December 18, 2024

To: City of Riverside Planning Division of CEDD via Principal Planner Brian Norton

From: Friends of Riverside's Hills

Re: Public Comment on PR-2021-00119 (Grading Exception), 6500 Hawarden Dr.

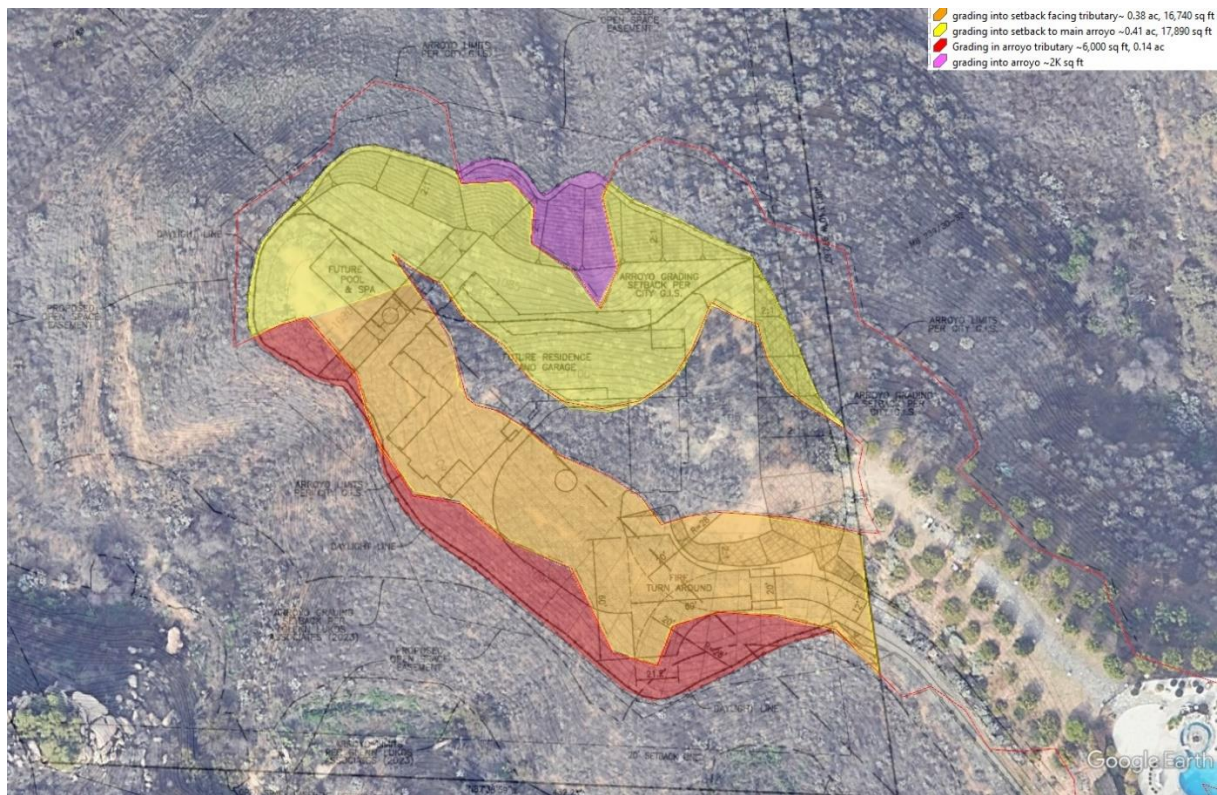
It is the City ordinance that defines the extent of the Alessandro Arroyo, and not Mr. Gurthrie's biological consultant Glen Lukos Associates (GLA). That ordinance, including that map, can only be changed by action of the City Council; any attempt by Mr. Guthrie, GLA, or staff to change the definition/map of the Alessandro Arroyo appears to us to be an attempted usurpation of the authority of the City Council. That attempt to use a different definition of the Alessandro Arroyo is exemplified in the Conceptual Grading Plans, where there are dashed line boundaries labeled "Arroyo Limits Per Glen Lukos Associates (2023)" and "Arroyo Grading Setback Per Glenn Lukos Associates (2023)", which differ greatly from the dash-dotted line boundaries shown there as "Per City G.I.S."

This (and the required Grading Exception Findings Justifications, examined below) shows that the applicant and his consultants are regarding the portion to be disturbed that is located within the boundaries of the City-mapped Alessandro Arroyo as being within an Alessandro Arroyo **tributary**. But that is incorrect. Indeed, the only tributary mentioned in the Guthrie letter, and repeatedly referred to in the GLA report as Feature 1, is a tributary south-southwest of the proposed graded area (“Project Footprint”) and shown in that report’s Exhibit 7, with the Riparian area shown there in green and a 50 foot buffer from that shown there in purple. As one can see from that Exhibit, only a fringe area of the Project Footprint faces the tributary and the bulk of the Project Footprint faces toward what the Exhibit 7 calls Riparian or Riverine areas, that is, parts of the Alessandro Arroyo and not the tributary. This is shown most dramatically in GLA Exhibit 3, an aerial photo with the Project marked on it, where one can see that the northern part of the Project Footprint faces the Arroyo’s main watercourse directly to its north and northwest, and not toward any tributary. This is shown explicitly in the figure below (next page).

The final page of the Conceptual Grading Plans has diagrams showing the proposed graded areas within the Arroyo (as defined in the Grading Code) itself (marked as 1,769 + 892 SF) and those within the tributary, the latter area being a small fringe along the south and southwest of the Project Footprint marked as 4,721 SF, and the “Graded Area Within City Defined Arroyo Grading Setback = 40,362 SF”, which, with the addition of the areas within the City-defined Arroyo (rather than in its setback, brings it close to a whole acre of land to be graded despite the Code prohibition of such grading. This is shown in more detail in the previous page of the Conceptual Grading Plans, with dash-dotted lines showing “Arroyo Limits Per City G.I.S.” and “Arroyo Grading Setback Per City G.I.S.”. It also shows much less inclusive areas of these Arroyo and Setback boundaries “Per Glenn Lukos Associates”.
